RECALL INSPECTION AND REPAIR INSTRUCTIONS

NHTSA Recall #: 22V-068

Models Involved: 2018-2022 Allegro & Breeze units with the 2000W inverter option

Purpose: To correct the torque on the DCD panel and replace buss bar with 2/0 cable and update torque label.

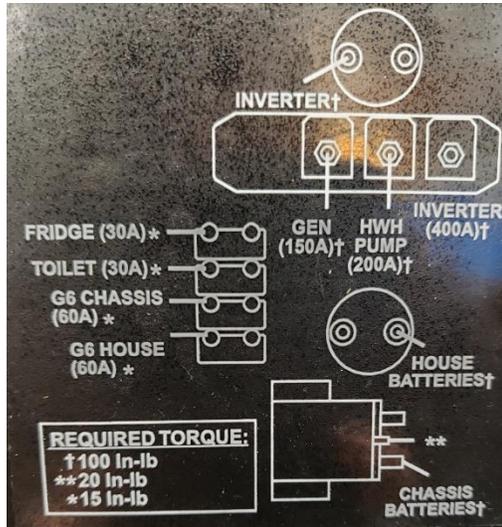
9. Using the cable provided, connect one end of the cable to the stud for the inverter switch. This will require using the torque wrench set on 100 in lbs.

10. Loop the harness around behind the board, and connect the other end of the cable to the stud for the 400A Zcase fuse. This will require using the torque wrench set on 100 in lbs.

11. Install the 5129401 CVR STUD RBBR RED on the studs. This will provide protection for the added cable
